# SUBSURFACE WASTEWATER DISPOSAL SYSTEM APPLICATION

Town or Plantation T5R8

Re: Bowlin Camps LLC

**SUBJECT:** Approval, First Time System Variance Request, Bowlin Camps, T5 R8

## SUBSURFACE WASTEWATER DISPOSAL PLAN

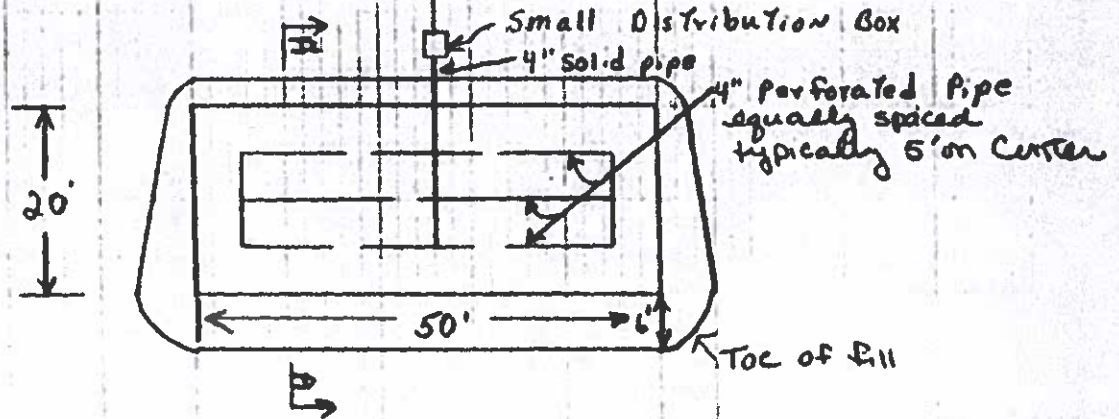
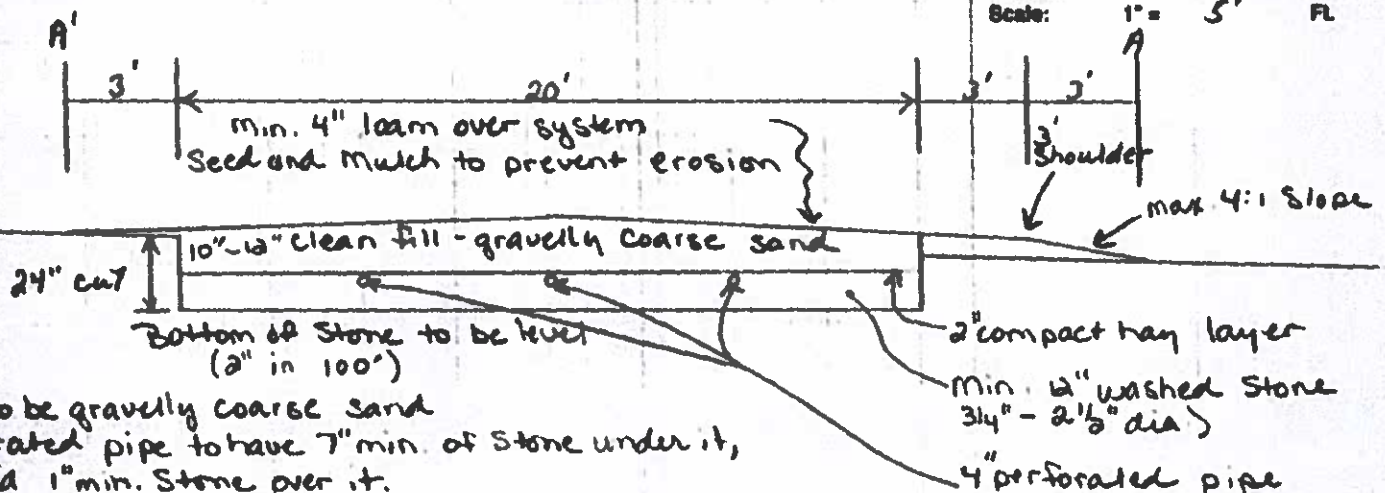
I have reviewed the HHE-200 Form completed on 12-28-97 for Bowlin Camps in T5R8. The size design and location of disposal field meets present code (6-1-99). The septic tank will have to be of monolithic construction or tested for water tightness in the presence of the local Plumbing Inspector. Local Plumbing Inspector should verify E.R.P. location.

If E.R.P. is missing, a site visit will be required to establish new one.
